P 526253

A 525654 UPGRADE

**ON-SITE SEWAGE DISPOSAL SYSTEM
HOWARD COUNTY HEALTH DEPARTMENT
BUREAU OF ENVIRONMENTAL HEALTH**

ADDRESS: 2600 Thompson Drive PROPERTY OWNER: Zaheer Chano

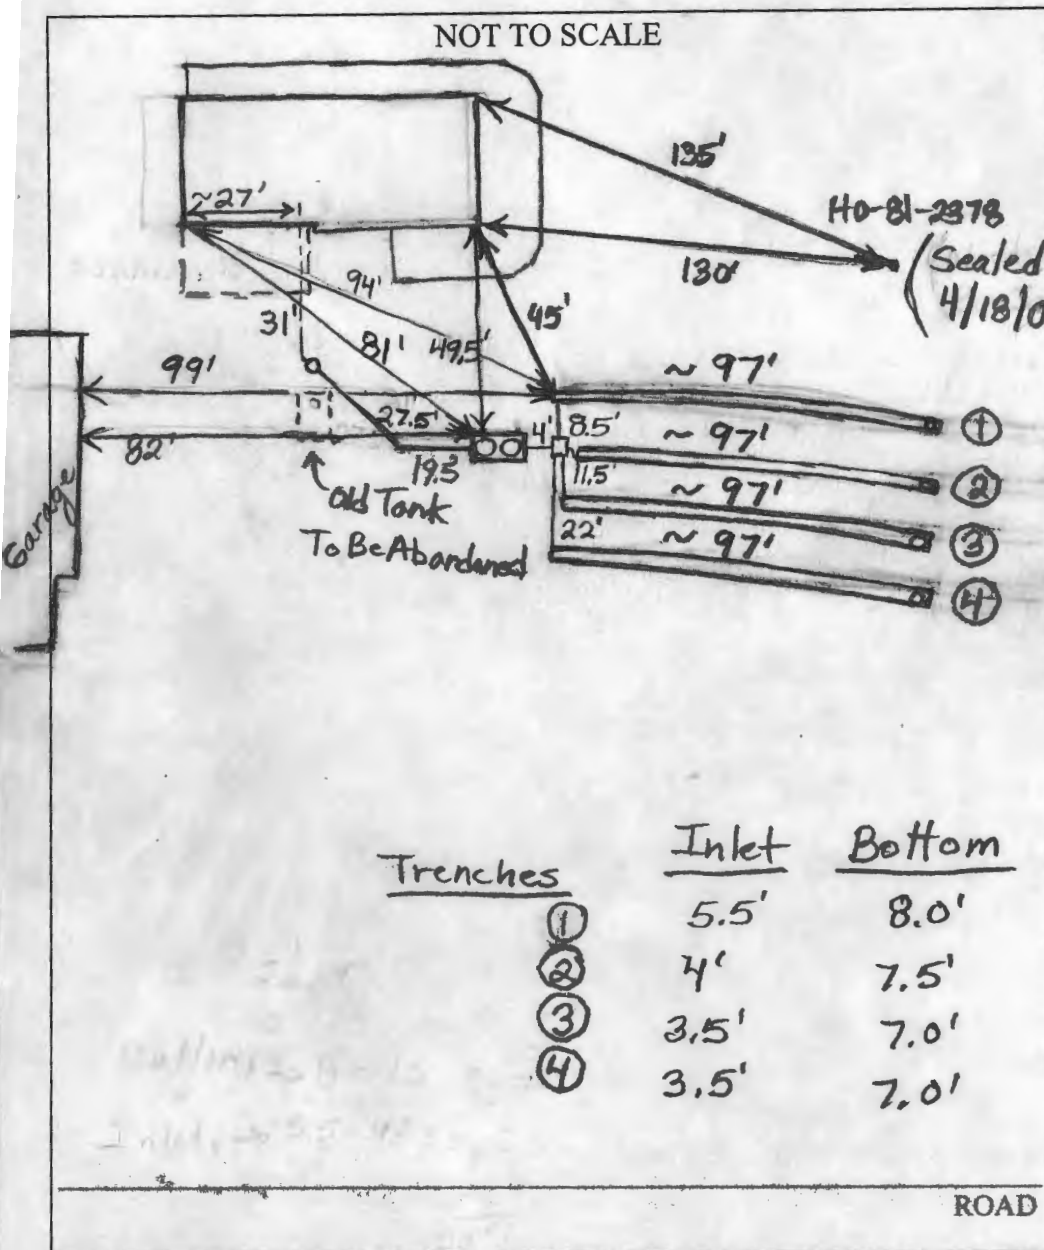
TRENCHES:	Trench to be 2 feet wide. Inlet 3.5 feet below original grade. Bottom maximum depth 7 feet below original grade. Effective area begins at 5 feet below original grade. 3.5 feet of stone below distribution pipe.
LOCATION:	
NOTES:	Tank needs to be 20' from addition. Addition needs to be staked or clearly located prior to layout inspection. Call for a layout inspection.

PRE-CONSTRUCTION 3/20/07 Flogles wants to install completely new system near the top perc. test holes. O.K. to make top

INSTALLATION 1 or 2 trenches as deep as 8' so that a pump isn't needed. Abandon old septic tank. (BB)

3/21/07 System installed. O.K. to backfill. Flogles said that old tank will be pumped out and filled in. (BB)
